P 534455  
 A UPGRADE

Tax ID # 1403289826  
**ON-SITE SEWAGE DISPOSAL SYSTEM**  
**HOWARD COUNTY HEALTH DEPARTMENT**  
**BUREAU OF ENVIRONMENTAL HEALTH**

ADDRESS: 11820 Homewood Road Ellicott City, MD 21042 PROPERTY OWNER: Stewart Residence

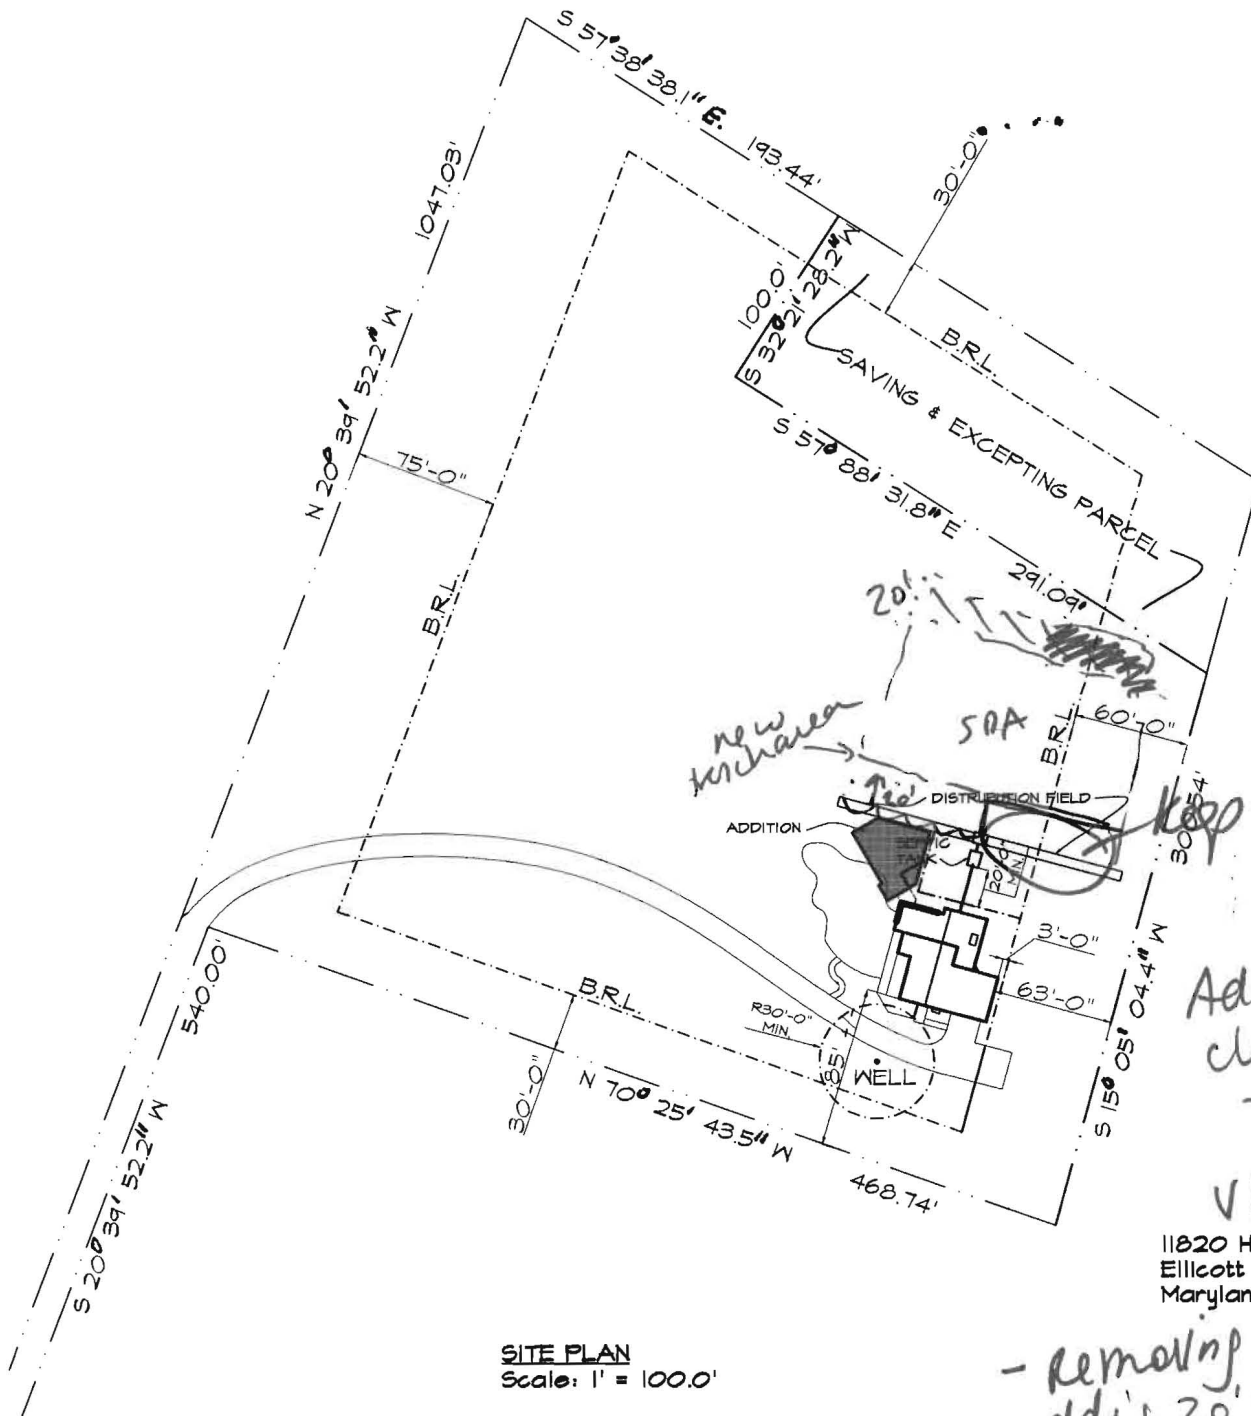
2/17/11 System completed. No f/u inspections called in. Need to add 6" inlet baffle to septic tank. Trenches need observation pipes @ end of trenches. Section of pipe from base need to add couple. Take out ball in pipe (wrong direction). Trenches need to be re-shot for correct center. (Jew) 2/18/11 septic obs. pipes installed properly. Baffle installed in S.T. Everything looks good. OK to cover.

**SITE PLAN**  
 Scale: 1" = 100.0'

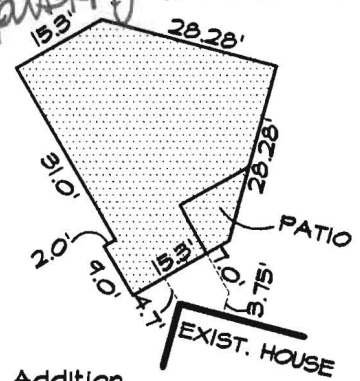
- Removing trenches
- adding 20' to SPA
- PATIO in new trenches.
